## Request for Class II Permissive Change

**FCC ID: VG8EM245AXX-P0**

**Data: December 3, 2011**

- 1、 Updated Mainboard as below:  
Original Mainboard

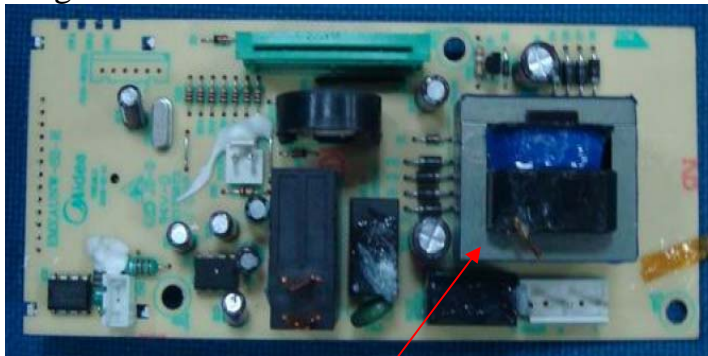
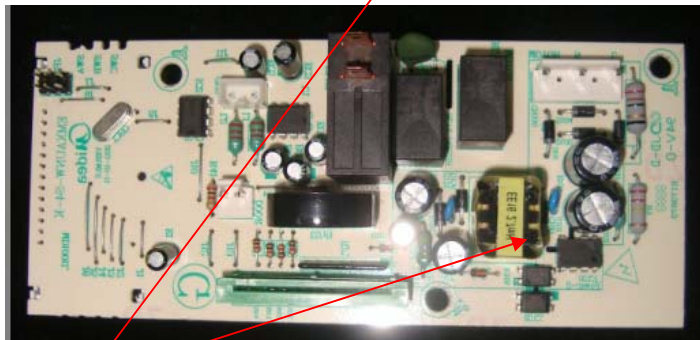
Changed linear power supply to switching power supply.

Note: Between them have the same specification of rated output power, Changed to the switching power supply, rated output power have not obvious change.

## 2. Updated the back view

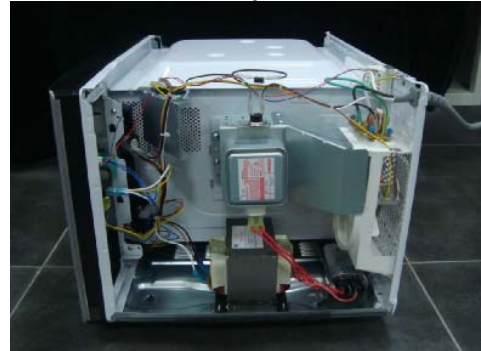
Original Internal photo

New Internal photo
